Plan Commission
Meeting of January 11, 2021
Agenda item #7, Legistar #63206

Changes from 8.24.2020 plans

4. Façades on Mixed-Use Buildings

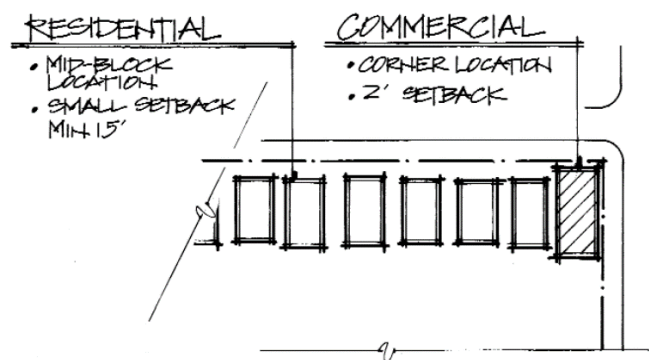
c. Kick panels High quality materials and special focus on design details is encouraged. It is recommended that this area utilize higher quality materials and design. The first floor window sill height shall be 18" to 36" above grade.

- *The cast stone base is 2' in height. Under the windows is 6"-8" kick panel. The four easterly side windows in the now commercial space also have been extended down to this 6-8" kick panel rather than terminating at the cast stone base.*

ATTACHMENT A: Building masses and spaces, current (with project outlined) and historic

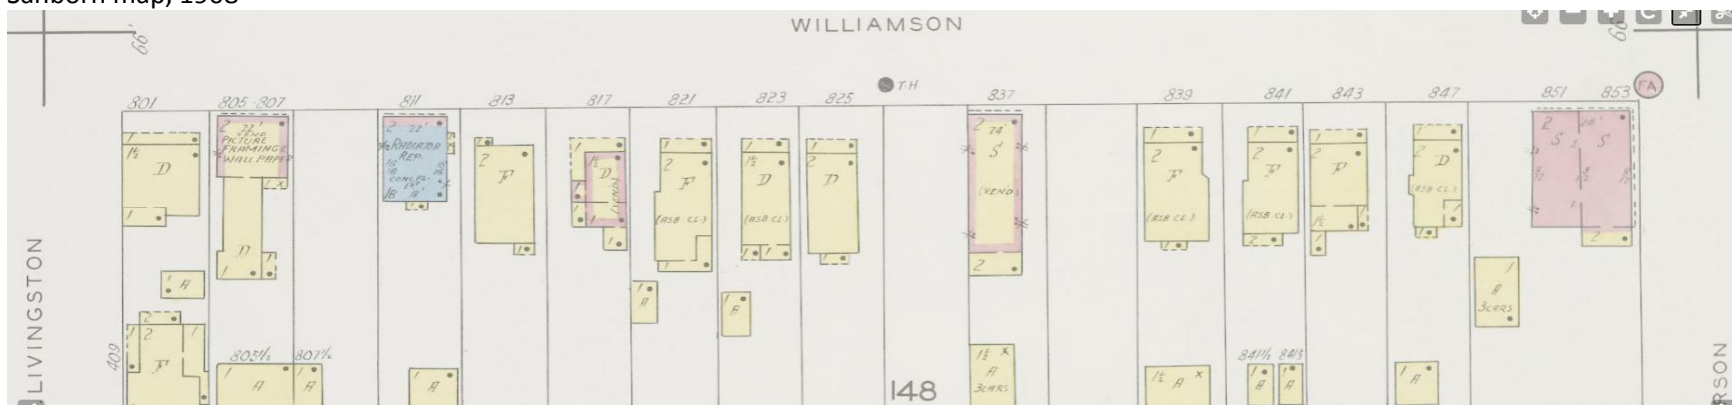
The middle setback, described in the Letter of Intent as creating "an appearance of two separate buildings located closely together, as is the case with other storefronts on this street" is approximately 5'1" in width (Page A1-1 of the plans shows 6', but this does not take into account the brick veneer). There is only one location where two storefronts are located that close together – between 803 (applicant's 2018 new building) and 805. Also, this building is not two storefronts: it is a storefront next to residential. The historical space between storefronts and residential was at least 12'. Attachment A is a visual, current and historic, reflecting buildings and spaces.
